South Texas Project Units 3 and 4 Docket Nos. 52-012 and 52-013 Response to Request for Additional Information

19.01-31, Revision 2 Response

RAI 19.01-31

Hurricane Evaluation - CTG at 0.5

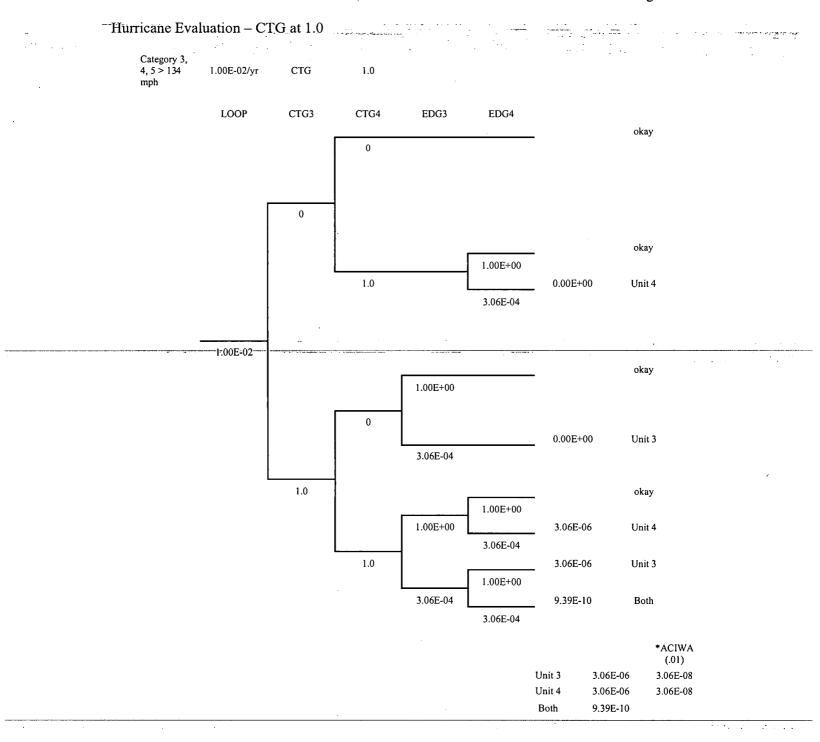
The staff has reviewed the applicant's response to RAI 19-18 and 19-20 and has additional questions. The shared fire water system design departure impacts the shutdown and full power hurricane risk assessment for the site. In accordance with 10CFR Part 52.79(d)(1), the staff requests that the applicant provide:

- (a) The shutdown and full power hurricane core damage frequency (CDF) and large early release frequency (LERF).
- (b) (b) A description of the dominant sequences contributing to the shutdown and full power hurricane CDF and LERF estimates.
- (c) The list of SSCs that were identified as risk significant for the Reliability Assurance Program with the supporting Fussell-Vesely (FV) and Risk Achievement Worth (RAW) for component basic events, human error probabilities, and common cause failures.

Using the simplified events trees below, the core damage frequency with credit for the ACIWA function with and without credit for the CTGs are:

CTG = 0.5	CTG = 1.0
Unit 3	1.5E=08	3.1E-08
Unit 4	1.5E-08	3.1E-08

Crediting the operation of RCIC for eight hours after the station blackout following a hurricane potentially reduces the failure likelihood for the ACIWA function from 0.01 to 0.001 as suggested in Appendix 19D.7.4.1 of the SSAR for the seismically induced station blackout. This would serve to further reduce the core damage frequency calculated in this assessment for the effect of hurricanes on STP Units 3 and 4. No evaluation of Large Release Frequency is necessary with quantitative results this low.
